ARCHITECT'S SUPPLEMENTAL INSTRUCTIONS

Date Issued:	August 13, 2021
Project:	Northpointe Medical Park- Labcorp- TI Building-'C'- Level 2 2326 North 400 East Tooele, UT, 84074
Architect's Supplemental Instructions:	ASI #1
To:	Saunders Construction 1113 South 500 West Bountiful, Utah 84010

Subject: Plan Review Response "**Northpointe Medical- Labcorp T.I.**" located at "Building 'C'- Level 2, 2326 North 400 East- Tooele UT 84074". Tooele City #: P21-421 (WC3 Project # 221-524-010)

Code Review Comments:

1 Code Compliance Floor Plan Level 2 - Overall
SCALE: 1/8" = 1'-0"

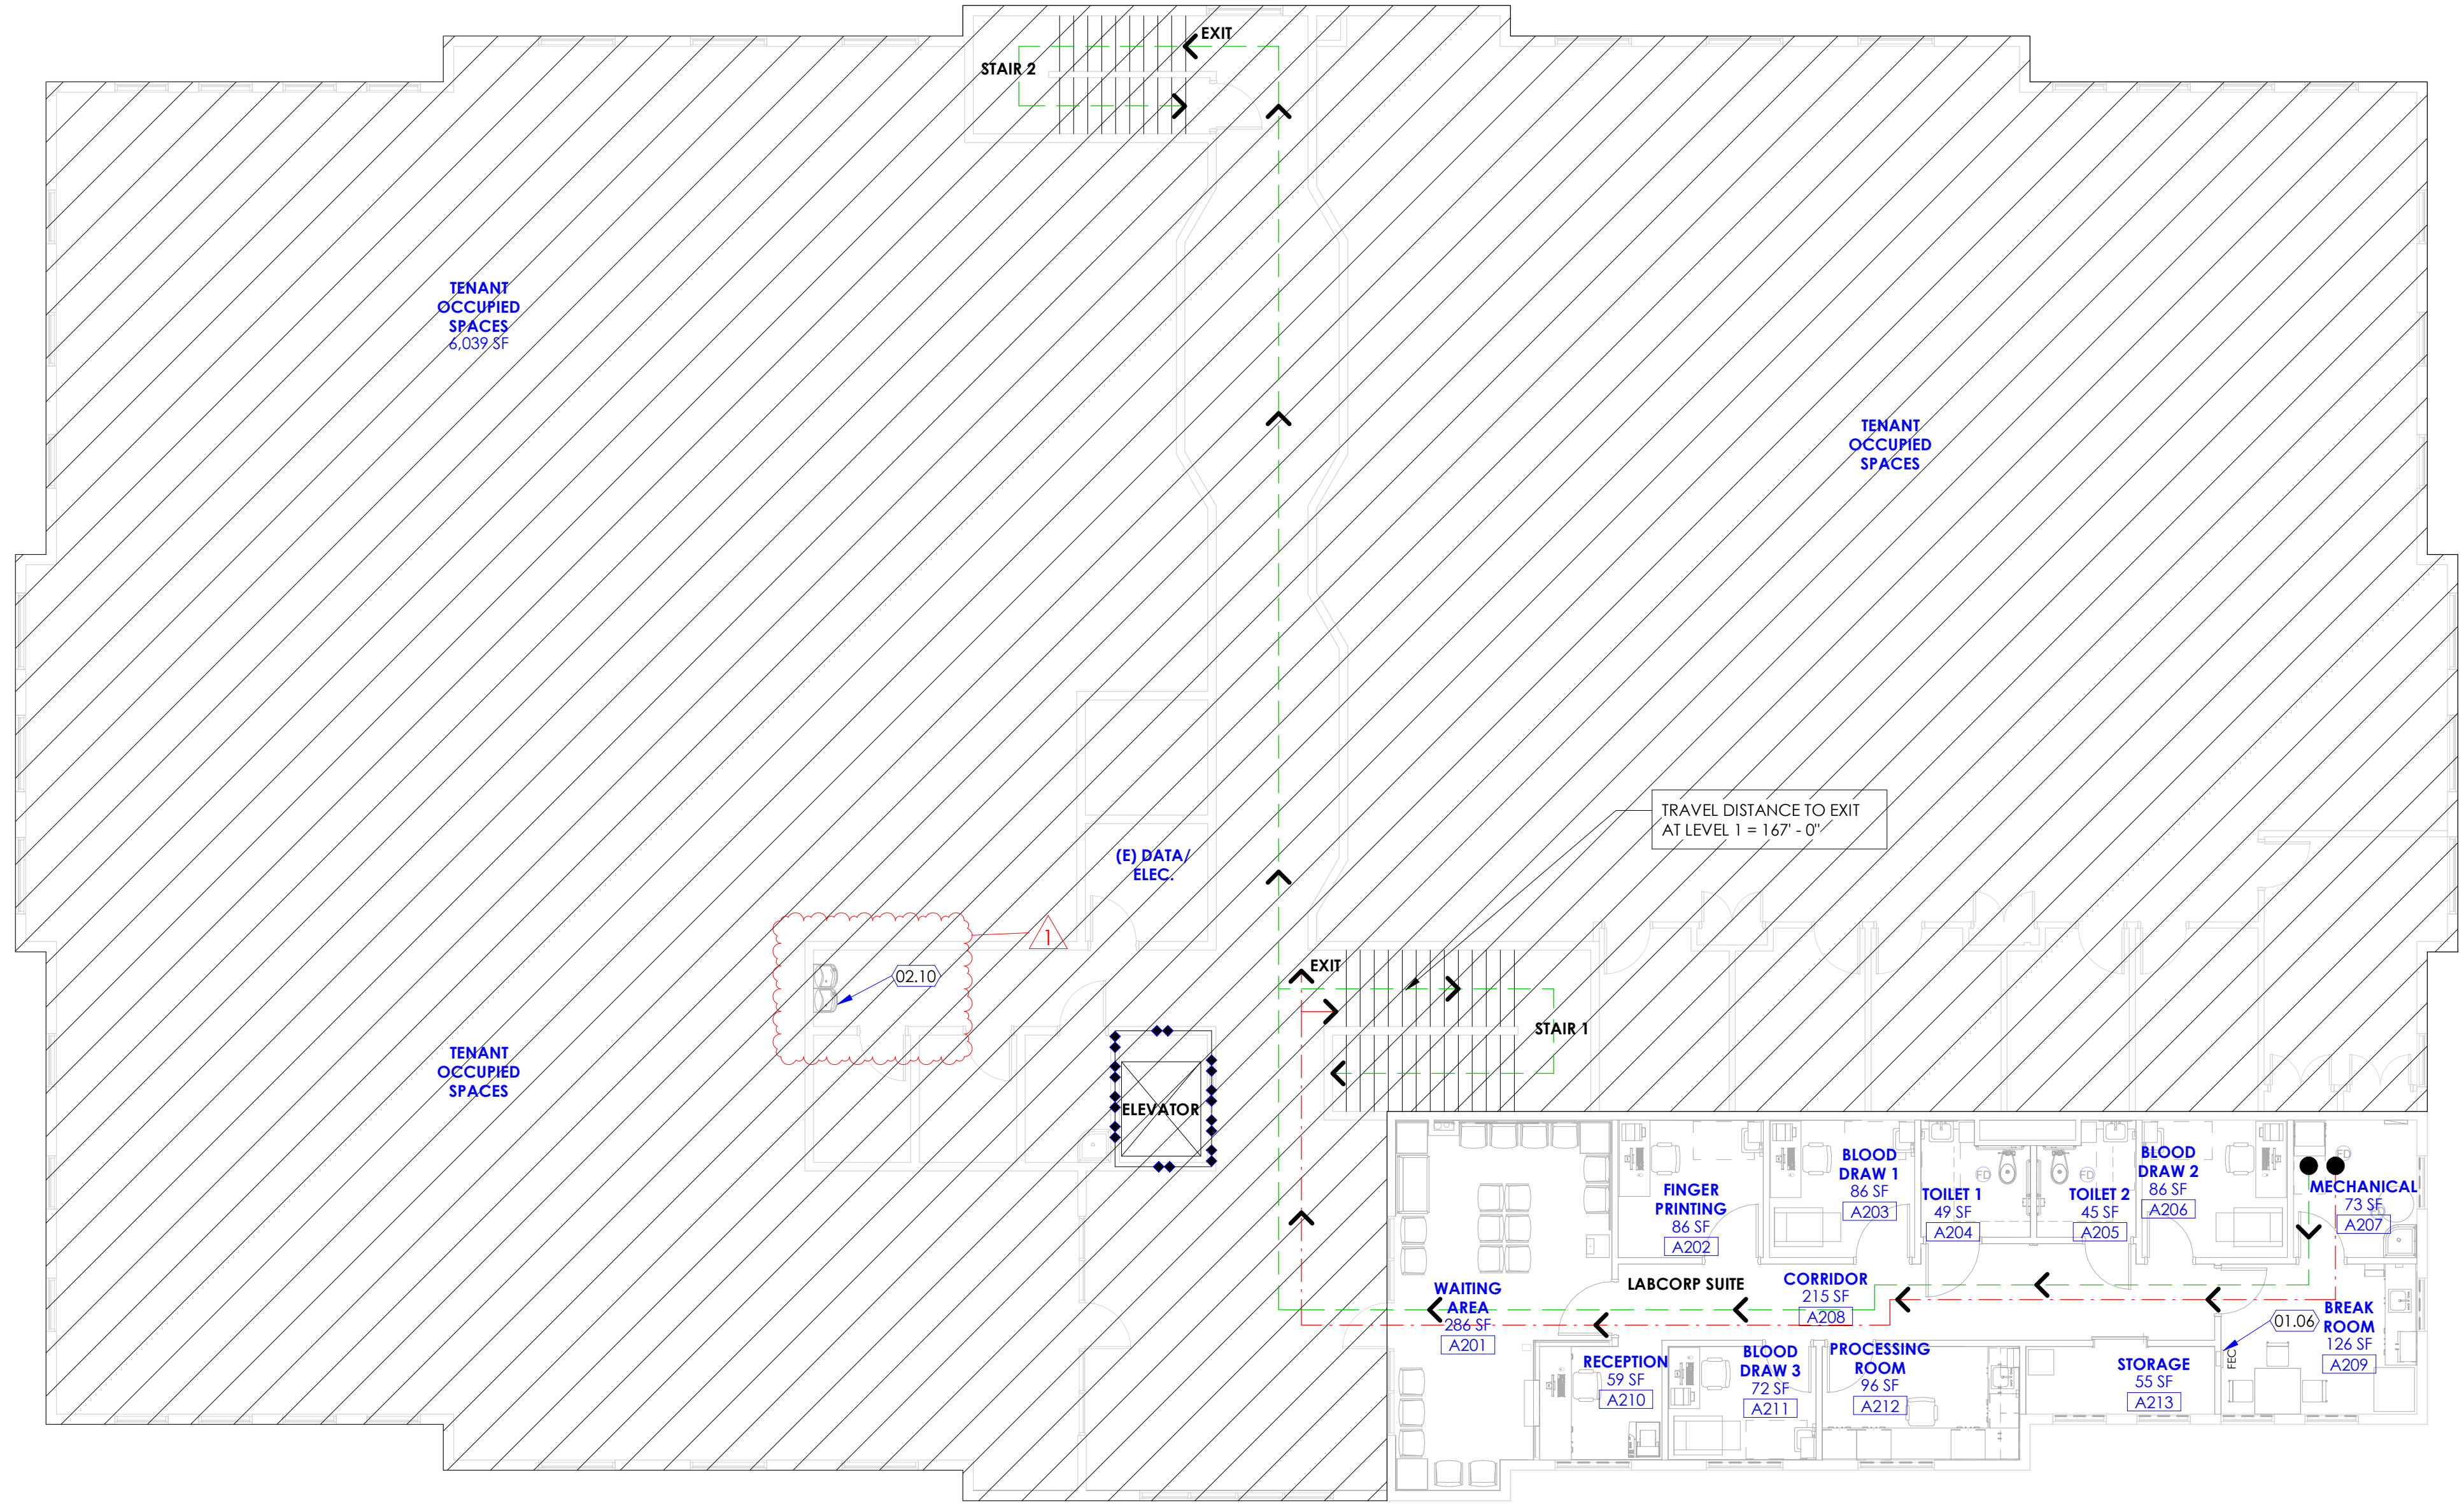
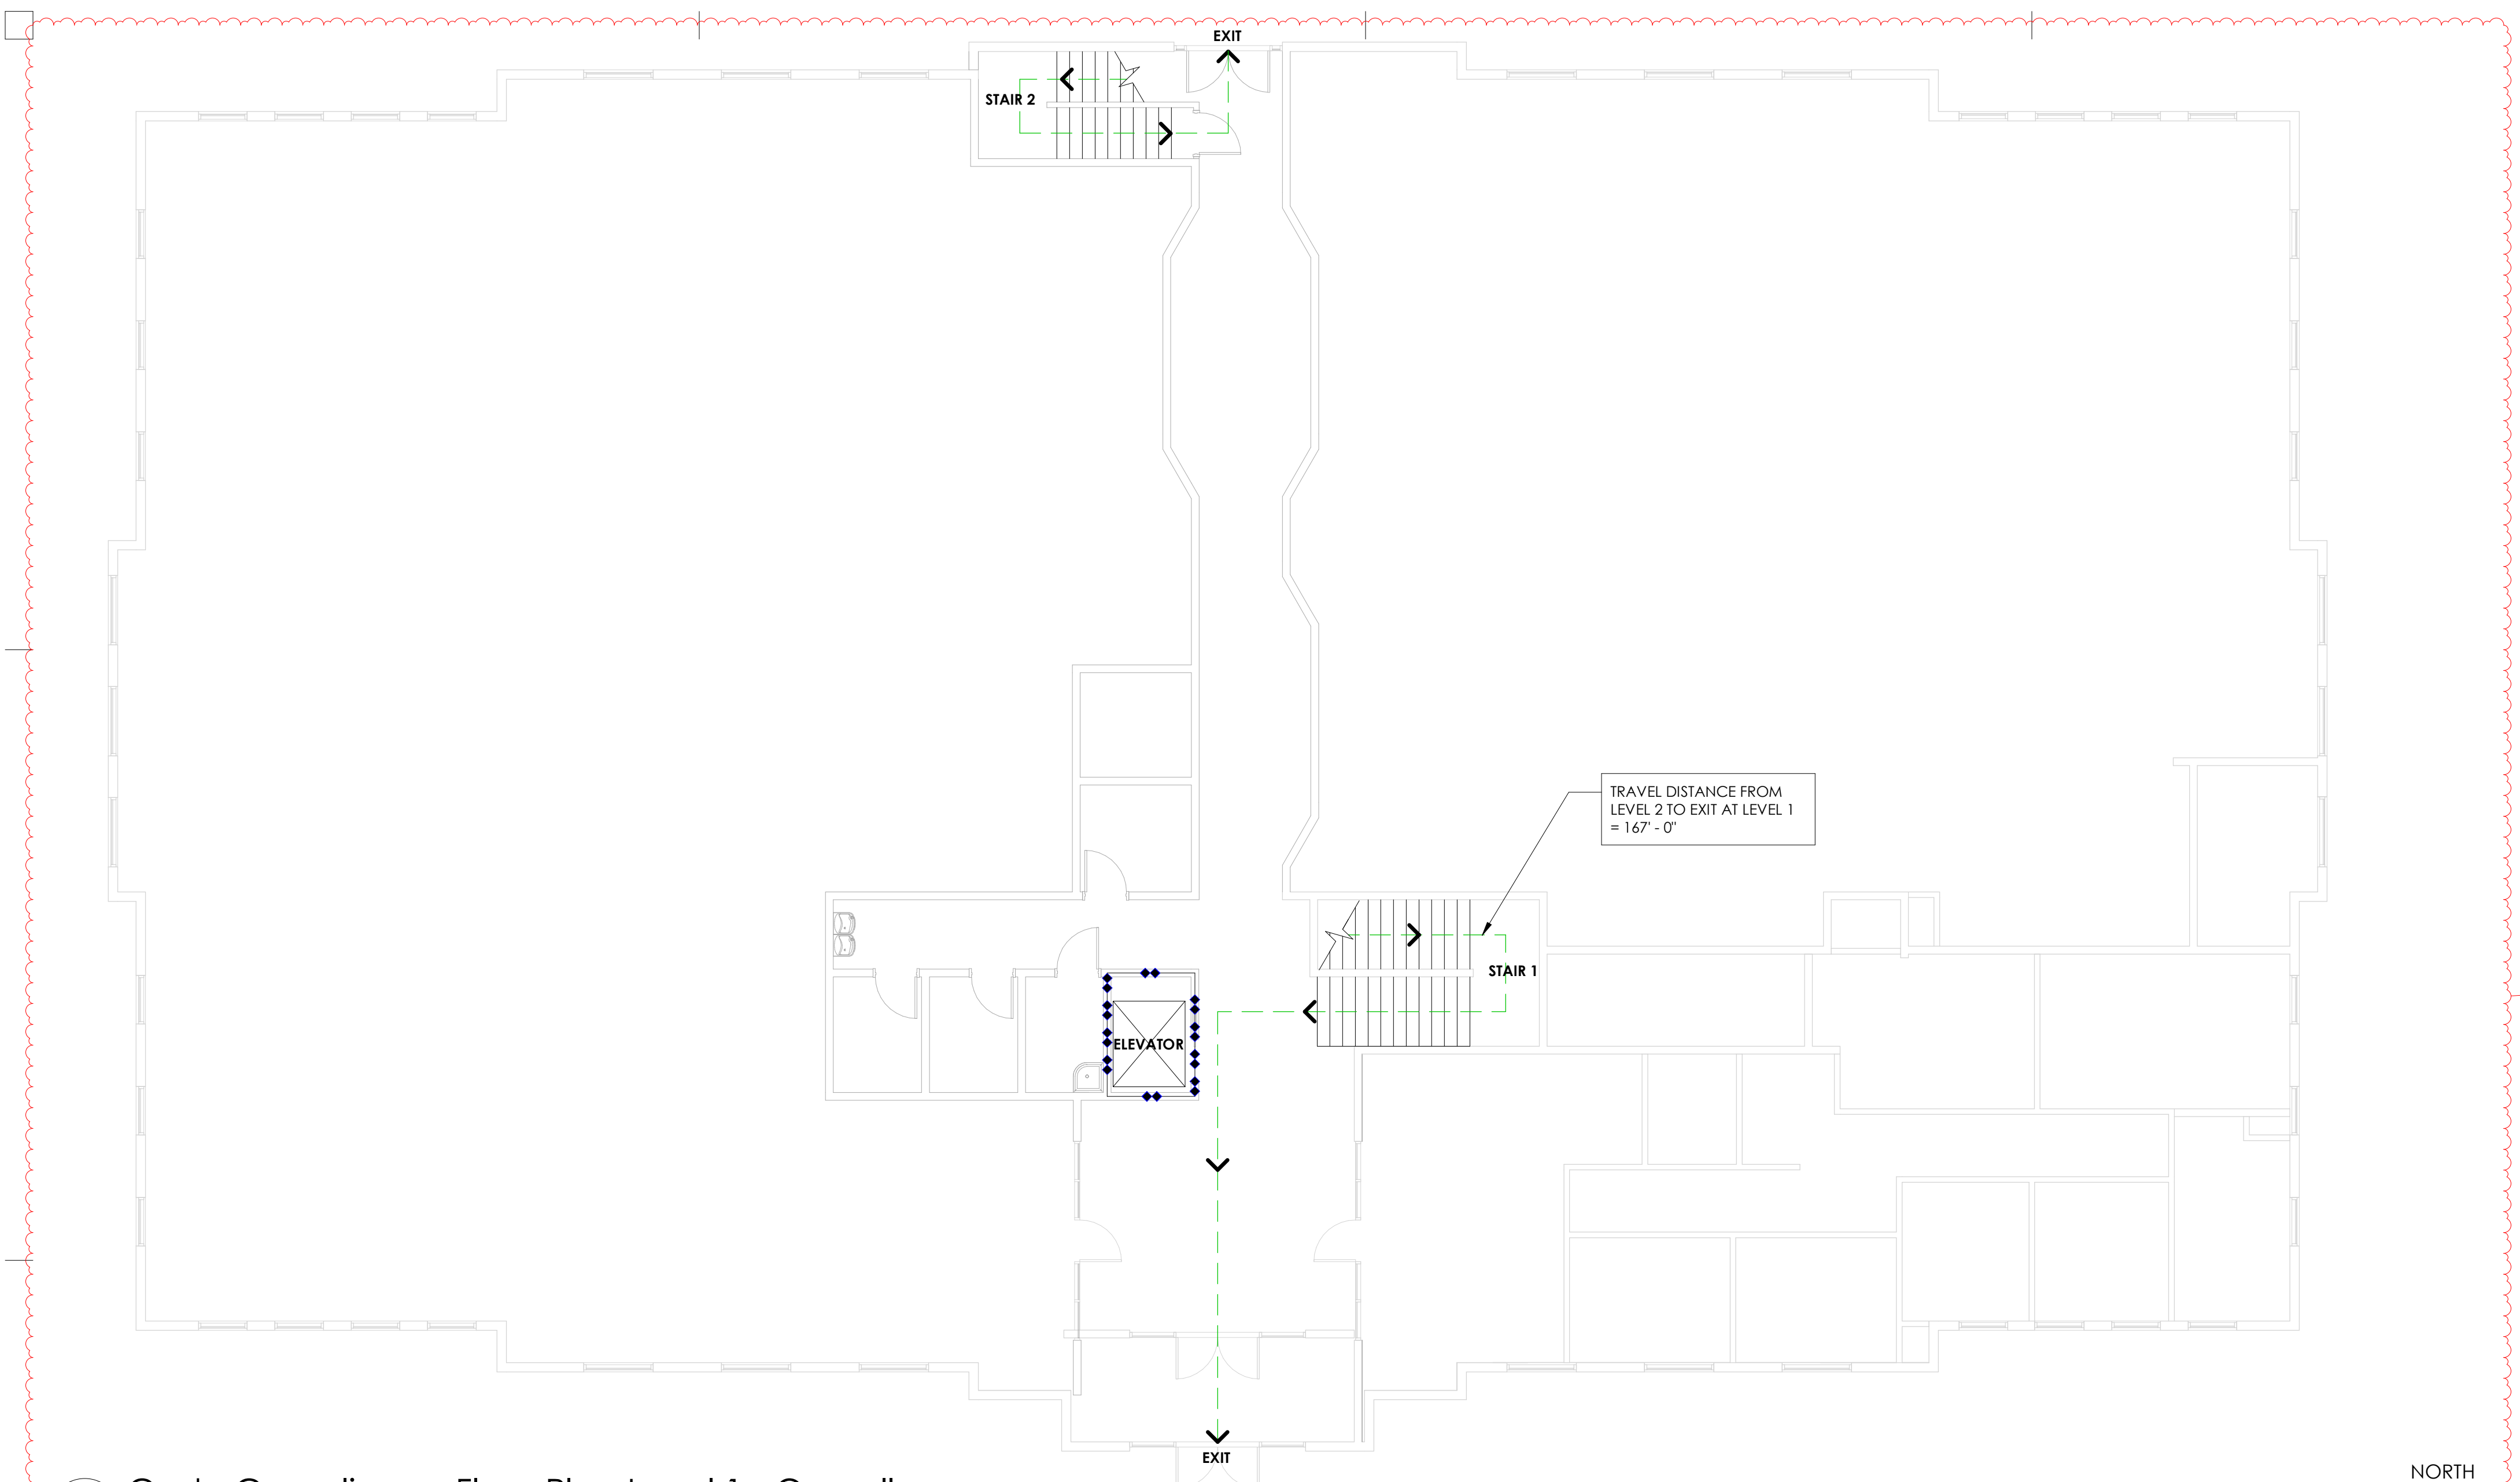
B. The Code analysis indicates that the maximum occupant load of the space is 10. Per the requirements of IBC Table 1004.5, the occupant load of the space is higher than what is listed. Please account for the waiting area, as these are considered assembly in nature and must be accounted for separately from the B occupancy.

I. The legend shows a common path of travel along with travel distance. These values have not been provided. Please show the distance for the common path of travel (IBC 1006.2) from the furthest point until the occupant has a chance to choose where to exit as the indication outside the door points to a wall.

II. Per the requirements of IBC 1017, please provide the first floor and show the maximum travel distance to the exit as it is unclear if this requirement is provided.

Response: Occupant load of the remodel area has been revised and higher occupancy listed for waiting area. See attached sheet G121 for more information.

Response: Common path and travel distance values have been provided. The path has been revised to show correctly. See attached sheet G121 for more information.

Response: First floor has been provided and Maximum travel distance from level 2 to the exit door at level 1 is noted. See attached revised sheet G121 for more information.

3 Existing Elevator ADA Requirements

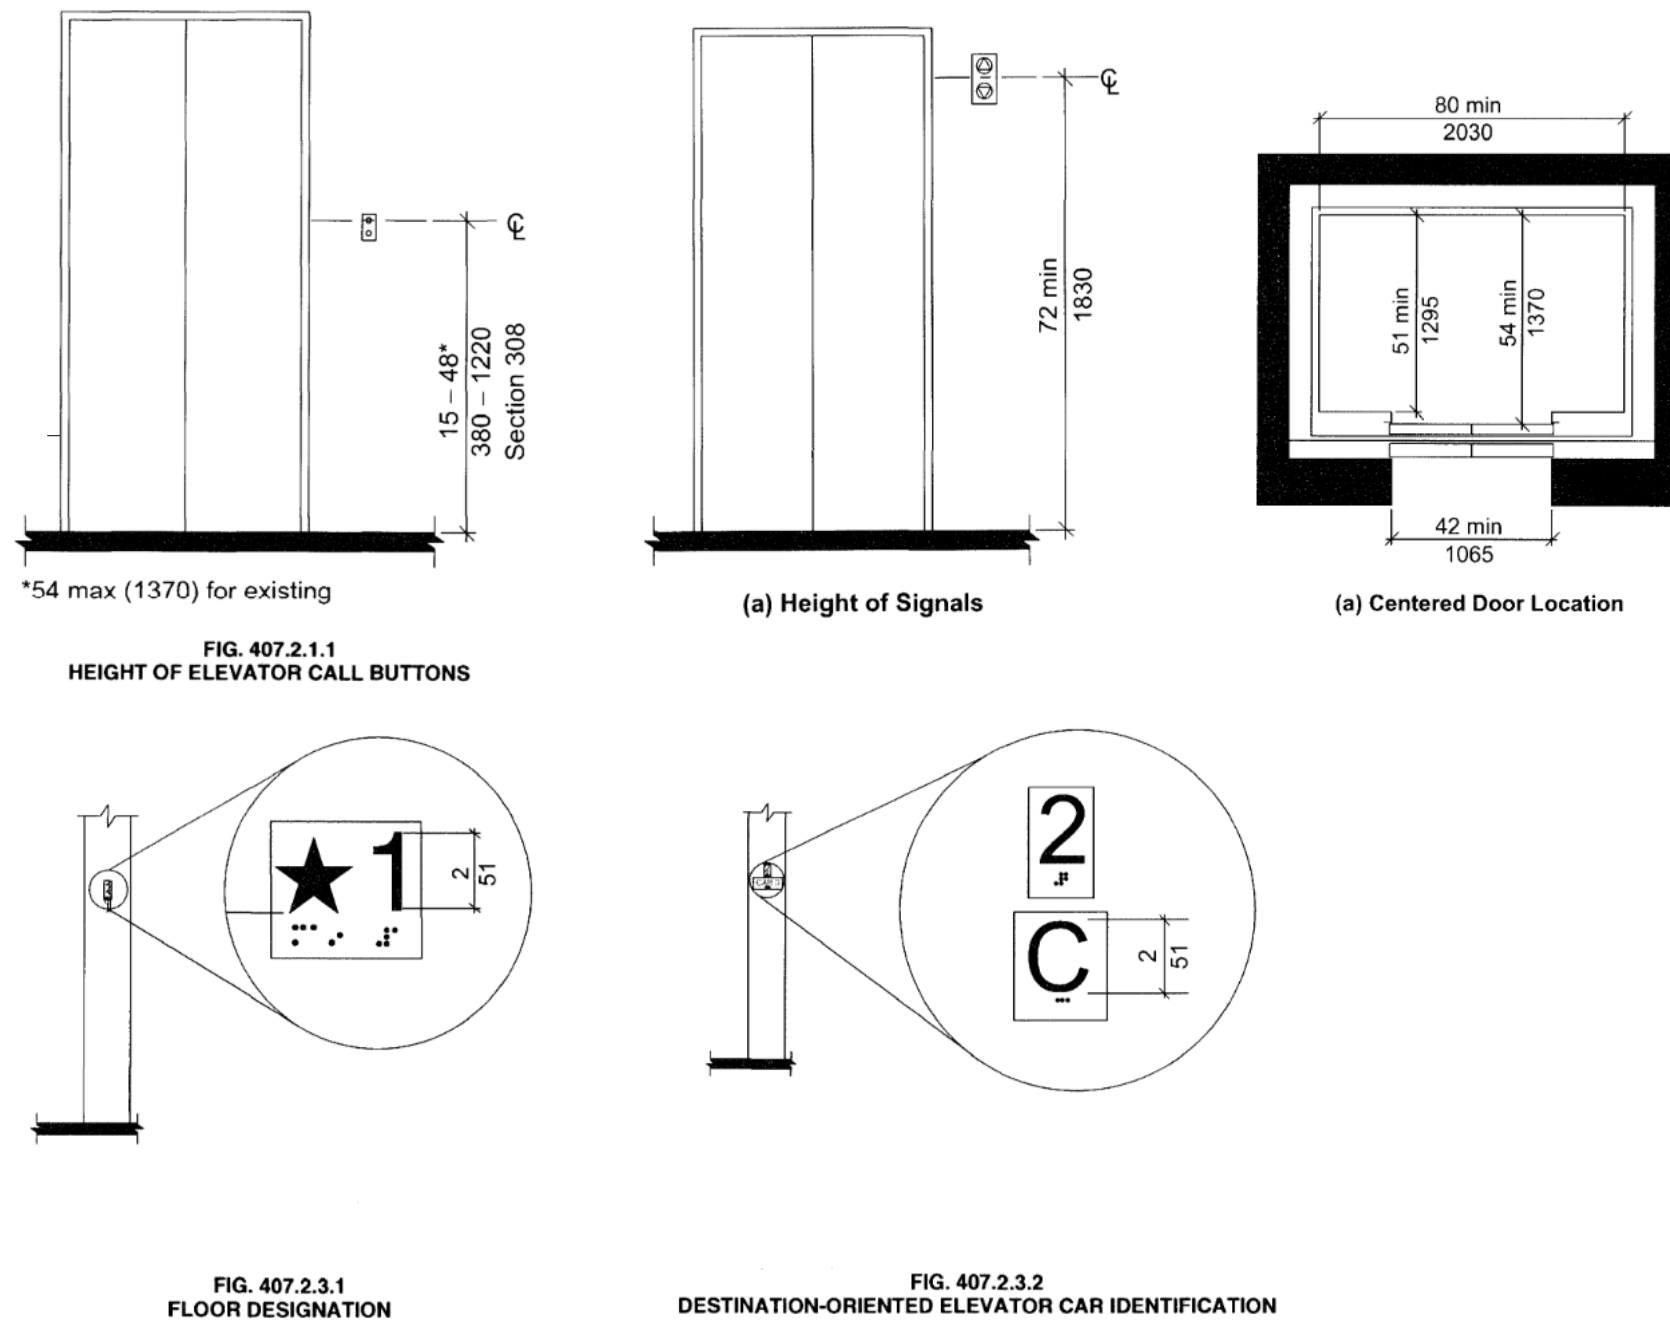
III. Provide details so that the contractor may verify that the existing elevator complies with Section 407 of ICC A117.1-09. This includes: Call Controls, Signals, Hoistway signage, Elevator sizes, Elevator buttons (in cab), Car position indicators, and Signage at elevator.

Response: The existing building elevator to our understanding complies with section 407 of ICC A117.1-09. We have also added note on sheet G002 and details on sheet A506A. Please note however that the scope of the project is tenant improvement of existing 1,400 sqft and has no impact on the existing elevator.
